Staff Report

Infill Housing Design Review Committee

File Number: 11-B-21-IH

Location: 442 Hiawassee Ave. **Parcel ID** 81 B C 008 01

Front Elevation

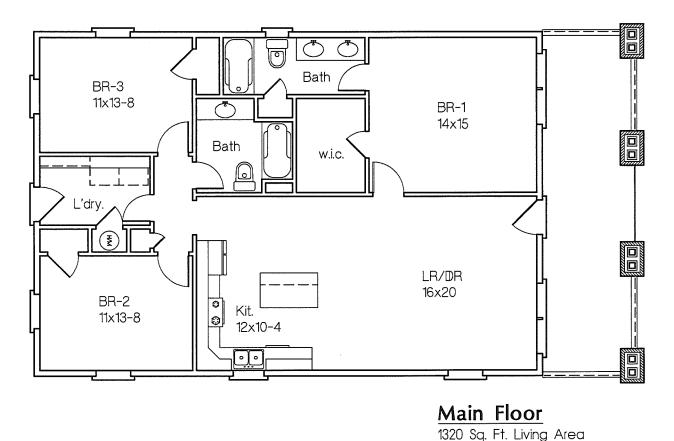
- 4. Overall, the one-story, three-bay façade is compatible with the historic houses on the block. The foundation height should be confirmed to be comparable in heights with historic houses on the block.

- 6. The proposed window and doors are compatible with historic elements on the block. There is sufficient transparency on side elevations. The applicant should select consistent window patterns on all elevations (either all 1/1s or 3/1s) and omit non-operable shutters.

- 7. The proposed 7/12 pitch roof meets the design guidelines, and the cornice returns and front-gable roof porch contribute additional complexity.
- 8. Overall materials are appropriate within the design guidelines. The vinyl siding should be lap siding with an overlap instead of Dutch lap or flush panel siding.

- 1) Incorporate a walkway from the front porch to the sidewalk or street;
- 2) Parking to meet Infill Housing guidelines and City Engineering standards, and be located at the rear of the property off the alley;
- 3) Confirm foundation height's consistency with nearby historic houses;
- 4) Use consistent window designs on all elevations and omit non-operable shutters;
- 5) Use vinyl siding with an overlap instead of Dutch lap or flush panel siding;
- 6) Incorporate one native or naturalized shade tree in front and rear yards.
